Current users who choose to or are required to update their DSP8.8 Software, Firmware & Apps

V1 4.4.18 DSP8.8 FW 1.2.7

Firmware Updates Include

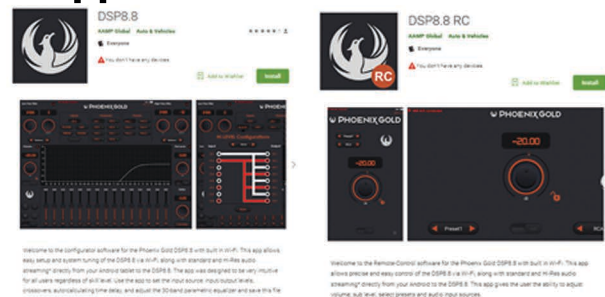
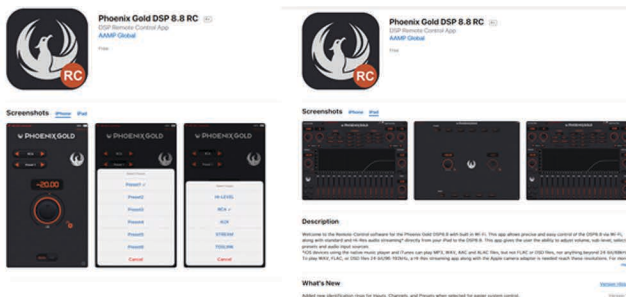
Added new audio signal configurations for RCA and Hi-Level inputs for easier system setup.

Added new visual indicators for each EQ band that is adjusted beyond flat for easier system tuning.

Added new identification rings for Inputs, Channels and Presets when selected for easier system control & setup.

Fixed bugs on Preset Copy and Preset Title to prevent DSP from unexpected rebooting.
